BOARD OF COMMISSIONERS

REVISED AGENDA

Monday, November 13, 2017 - 6:30 PM

G. SALDO Application #2014-D-02 - ***Caucus*** - 145 King of Prussia Road - Preliminary Land Development

SEE SHEET C3.1 FOR SITE DATA AND ZONING DATA TABLES

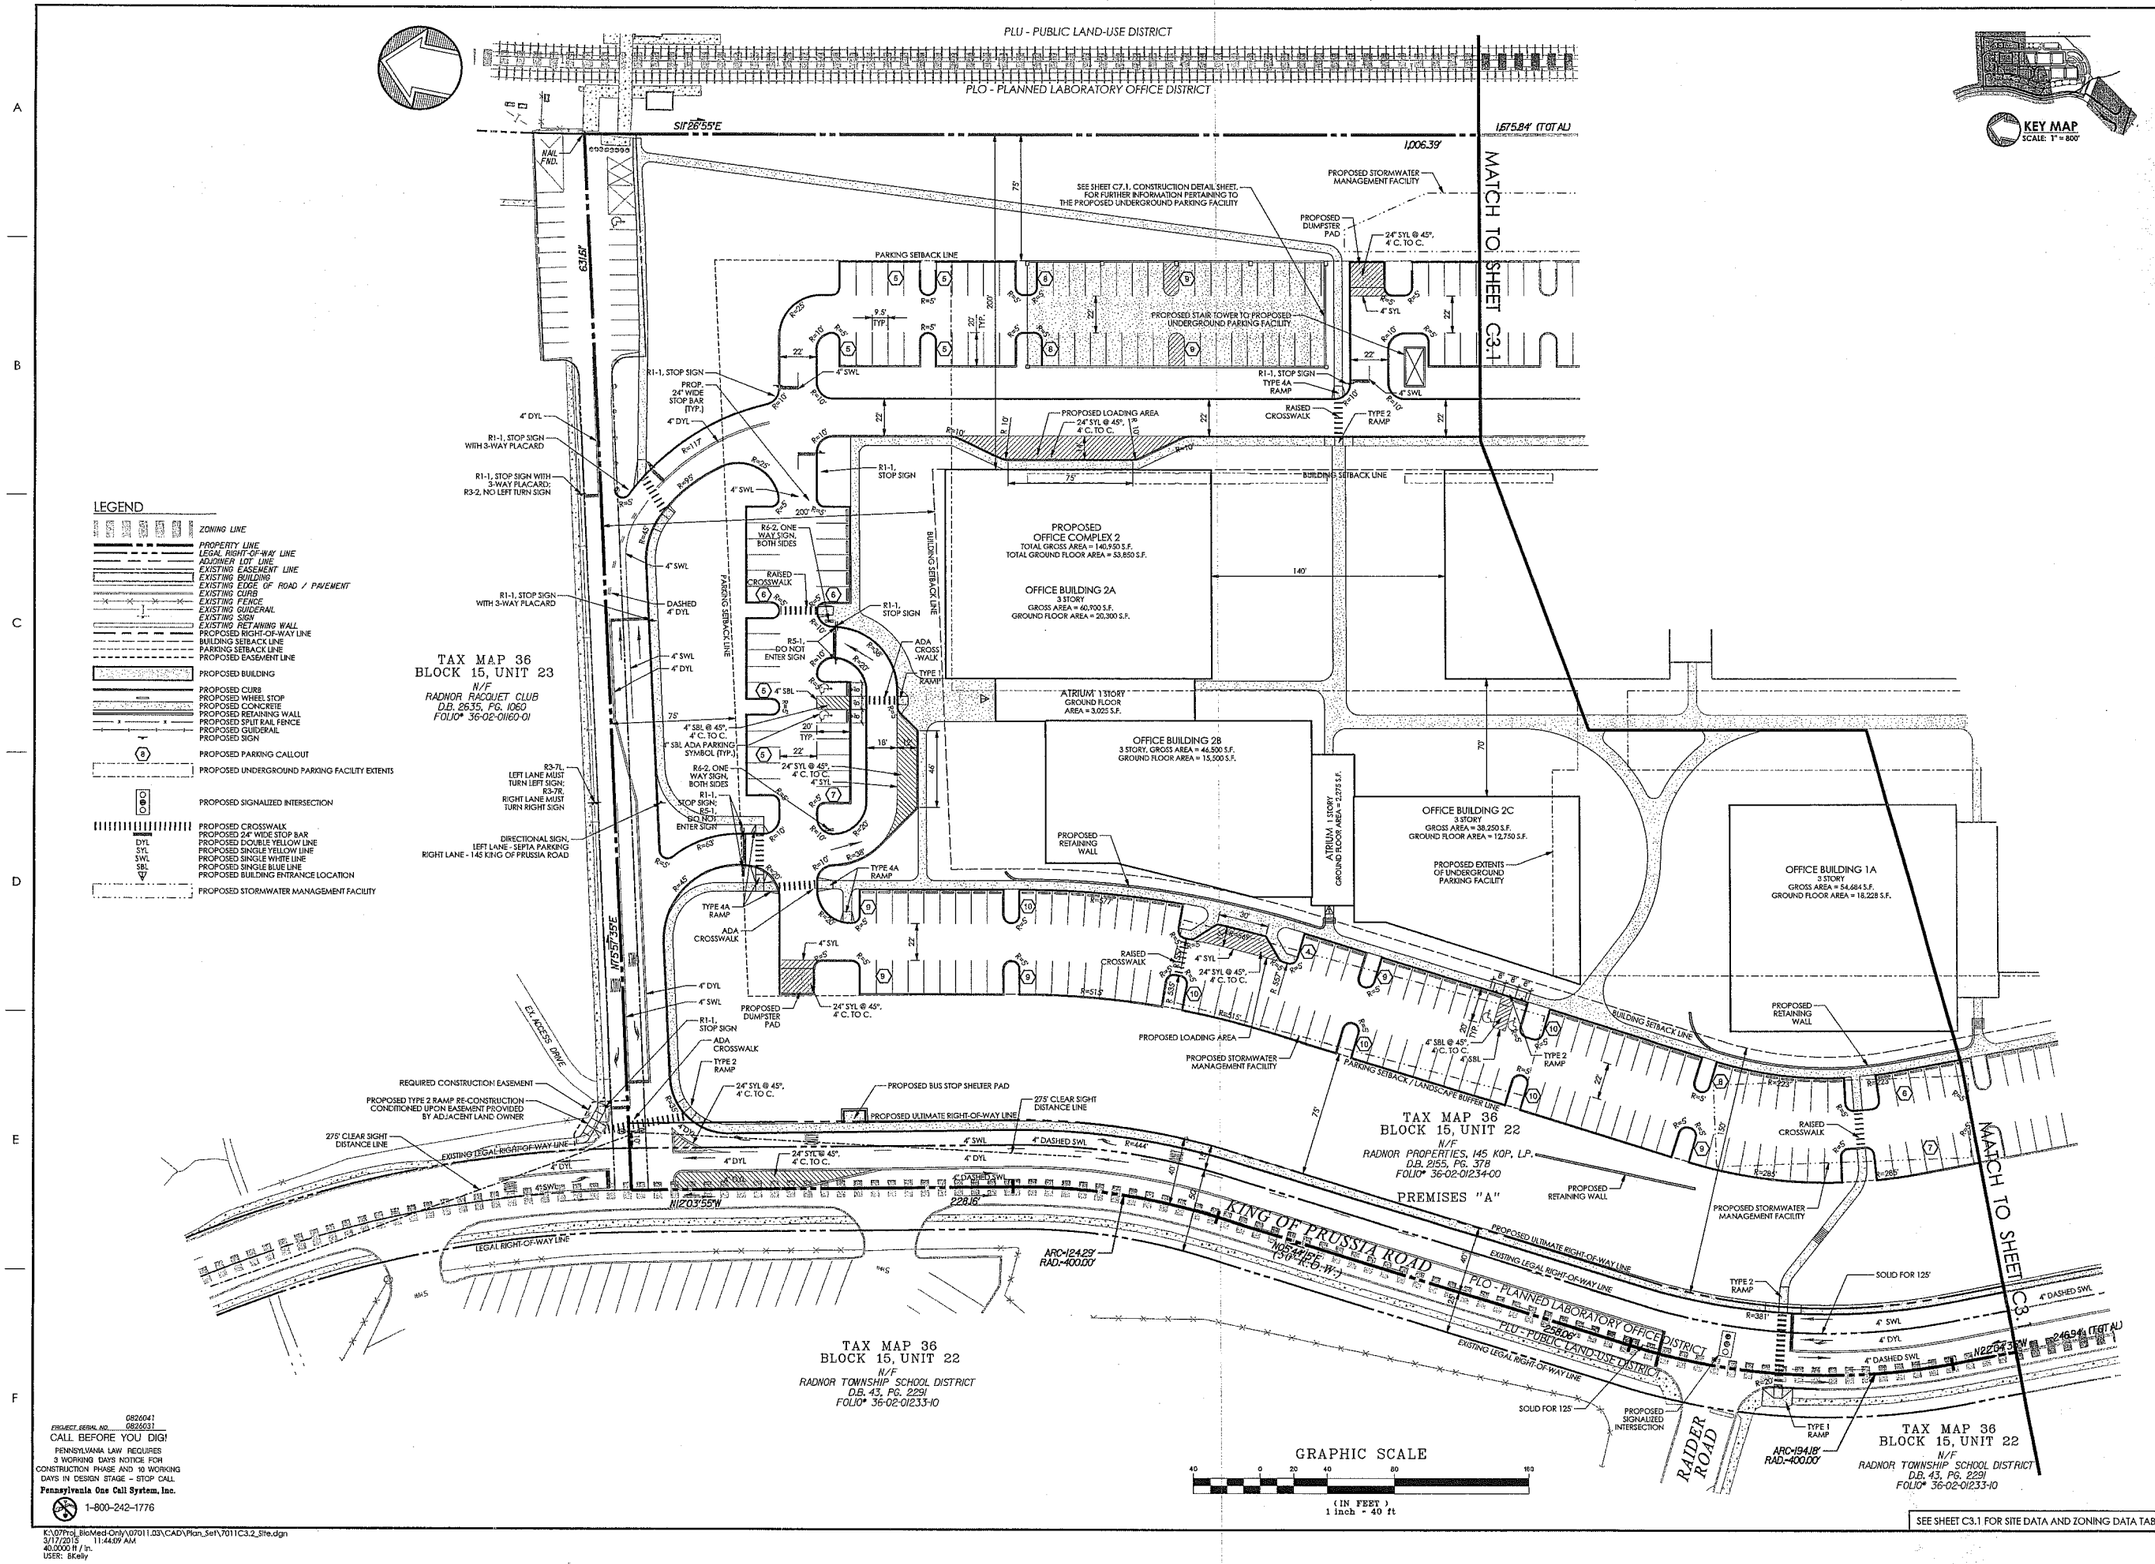
4. Sheet C3.0 (5 of 30): Provide contiguous right-of-way lines on the west side of King of Prussia Road, near Route 30.
5. Sheet C3.1 (6 of 30):
    i. Include typical midblock signage for the pedestrian crosswalk at the proposed Trail and the Southern Access. (W11-2 *Pedestrian* Sign and W16-7P *Diagonal Downward Point Arrow* Plaque)
    ii. Provide pedestrian ramps at the following locations:

4. Sheet C3.0 (5 of 30): Provide contiguous right-of-way lines on the west side of King of Prussia Road, near Route 30.
5. Sheet C3.1 (6 of 30):
    i. Include typical midblock signage for the pedestrian crosswalk at the proposed Trail and the Southern Access. (W11-2 *Pedestrian* Sign and W16-7P *Diagonal Downward Point Arrow* Plaque)
    ii. Provide pedestrian ramps at the following locations:

1. Revise the parking layout to eliminate the approximate 3.5 foot wide space in the northeast corner of the parking lot in front of Building 4B
2. Eliminate the 4"SWL line on the one-way driveway south of Building 4C.
3. Verify all parking stalls have a minimum 9.5 foot width.
4. Install a second R6-6 BEGIN ONE WAY at the beginning of the one-way driveway located in front of Building 4C at the beginning of the circle area and include the sign on the detail sheet (C7.4). Eliminate the R6-2 ONE WAY sign as it is unnecessary.

1. Revise the parking layout to eliminate the approximate 3.5 foot wide space in the northeast corner of the parking lot in front of Building 4B
2. Eliminate the 4"SWL line on the one-way driveway south of Building 4C.
3. Verify all parking stalls have a minimum 9.5 foot width.
4. Install a second R6-6 BEGIN ONE WAY at the beginning of the one-way driveway located in front of Building 4C at the beginning of the circle area and include the sign on the detail sheet (C7.4). Eliminate the R6-2 ONE WAY sign as it is unnecessary.

3. §280-103 – The parking requirement table provided on Sheet C-3.1 of the plan is incorrect for Building 4. Building 4 requires 477 spaces, not the 227 shown. The total parking required for the project should be revised to indicate 1,801 spaces required.

3. §280-103 – The parking requirement table provided on Sheet C-3.1 of the plan is incorrect for Building 4. Building 4 requires 477 spaces, not the 227 shown. The total parking required for the project should be revised to indicate 1,801 spaces required.

P. We have revised the gore striping, as requested.
Q. We have revised the sidewalk location as requested.
R. We have revised Sheet C3.1, as requested.
    1. The stall in question is not 3.5 ft. wide, but rather the remainder is within the subsurface parking. Refer to the subsurface parking detail for the continuation of this stall.

CONCEPTUAL UNDERGROUND PARKING FACILITY - LEVEL P1

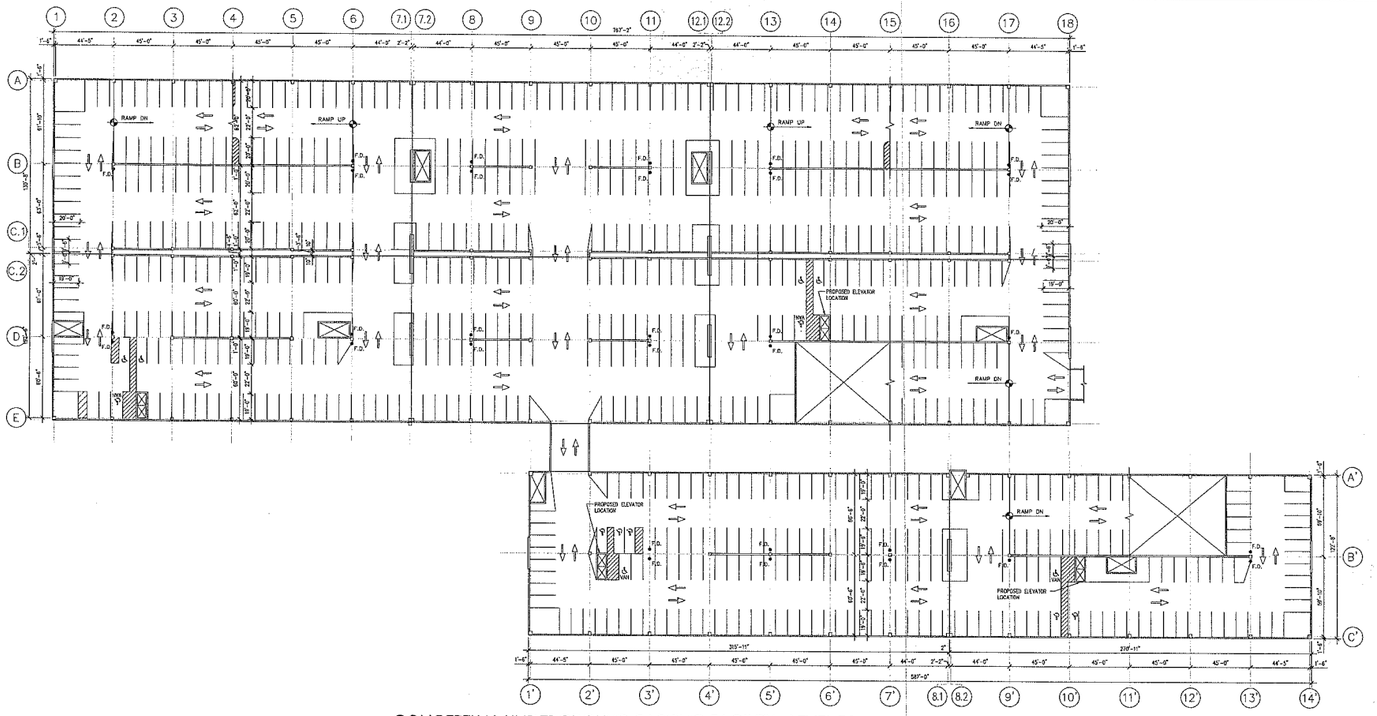
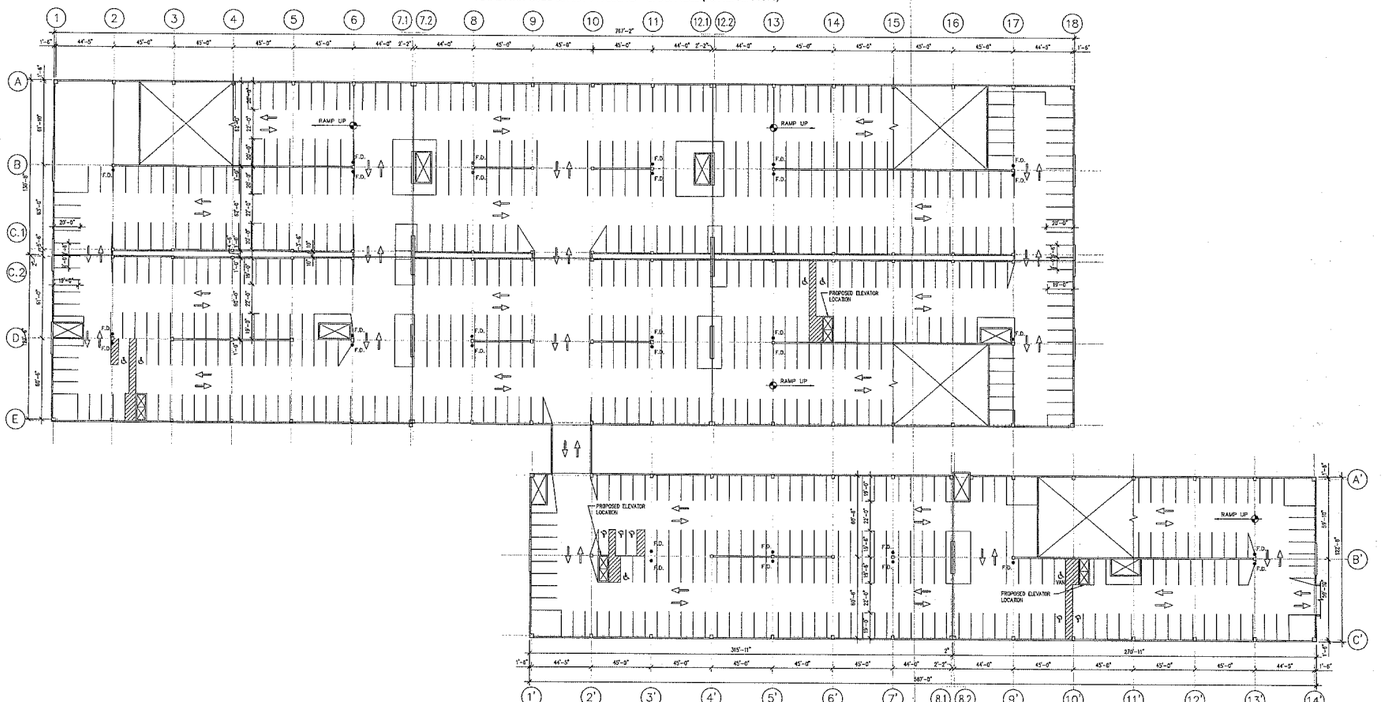
6. Sheet C7.1 of the plans indicate that "the design and layout of the underground parking structure facility shown is strictly conceptual. Refer to the plans designed by Tim Haas for finalized layout and structural design specifications." The referenced plans must be provided for review.

6. Sheet C7.1 of the plans indicate that "the design and layout of the underground parking structure facility shown is strictly conceptual. Refer to the plans designed by Tim Haas for finalized layout and structural design specifications." The referenced plans must be provided for review.
